CITY OF ALBUQUERQUE

**RE: Academy Dental Center
6421 Holly Ave NE
Grading and Drainage Plan
Engineer's Stamp Date: 08/22/19
Hydrology File: C18D038A**

Renée C. Brissette, P.E. CFM
Senior Engineer, Hydrology
Planning Department

Grading Plan

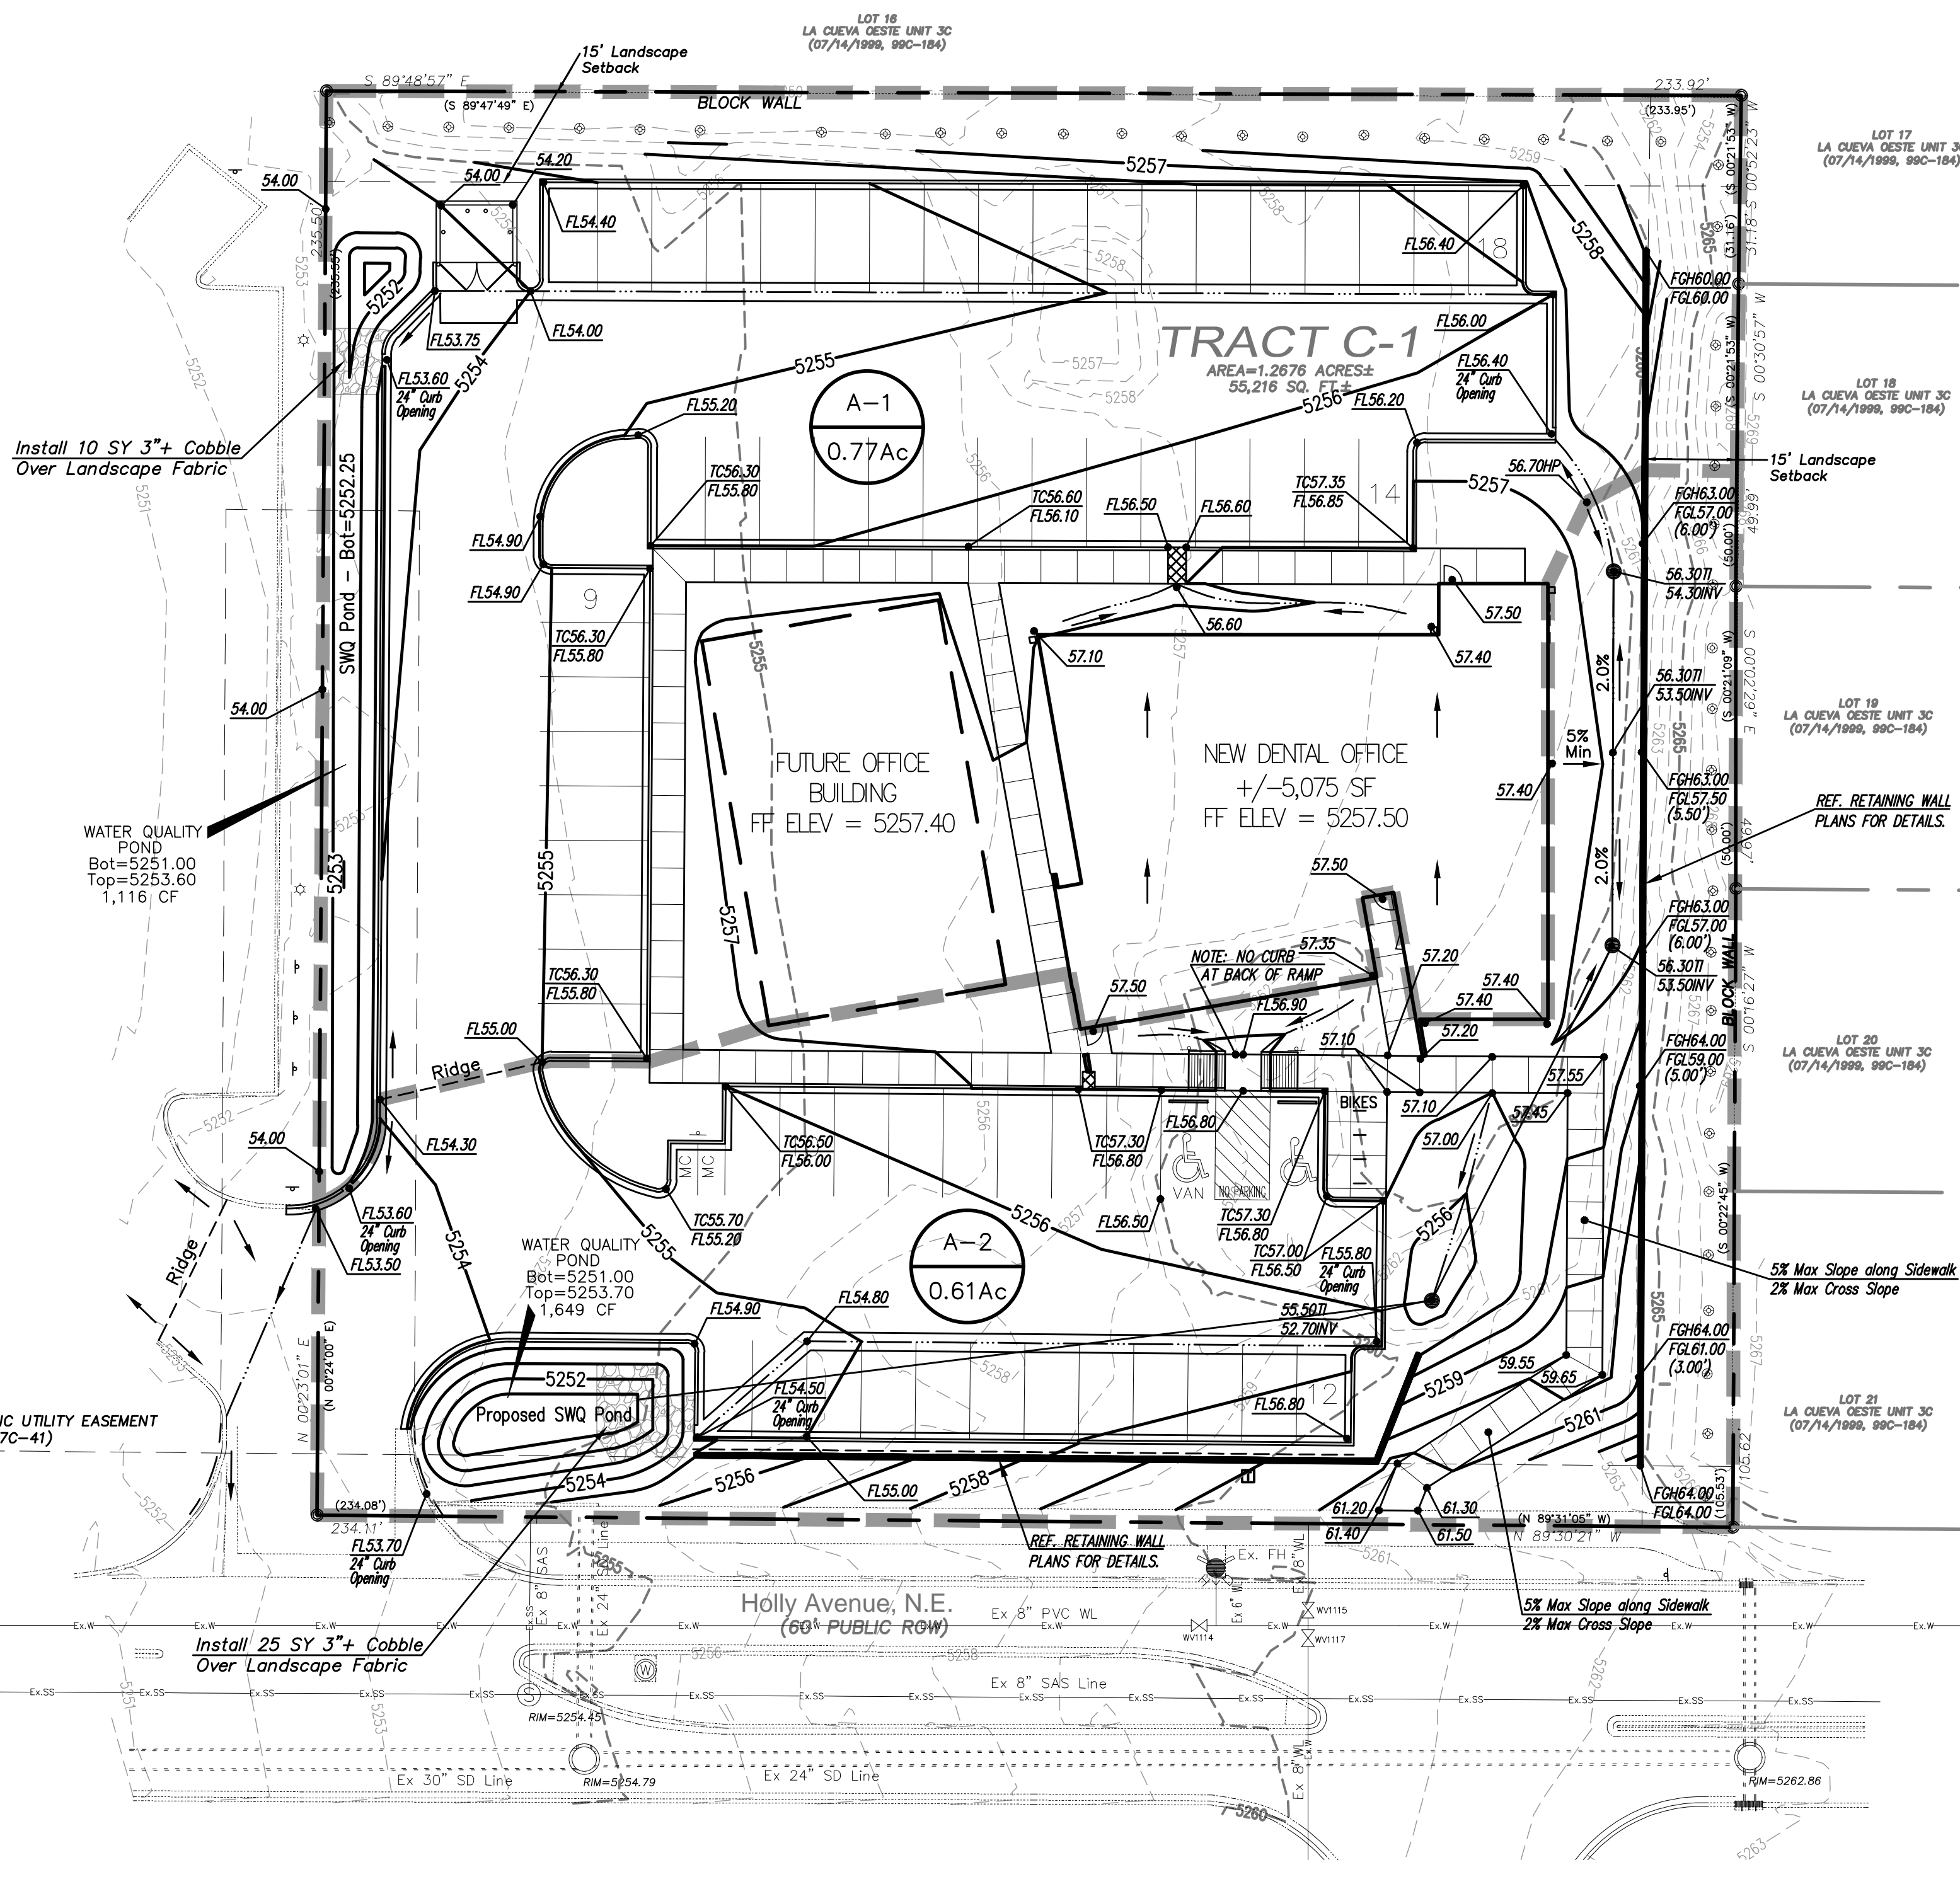
Based upon the information provided in your submittal received 08/20/2019, the Grading and Drainage Plan is approved for Building Permit.

Please attach a copy of this approved plan in the construction sets for Building Permit processing along with a copy of this letter. Prior to approval in support of Permanent Release of Occupancy by Hydrology, Engineer Certification per the DPM checklist will be required.

Please provide Drainage Covenant per Chapter 17 of the DPM prior to Permanent Release of Occupancy for the stormwater quality ponds. Please submit these to the 4th floor of Plaza de Sol. A \$25 fee for each will be required.
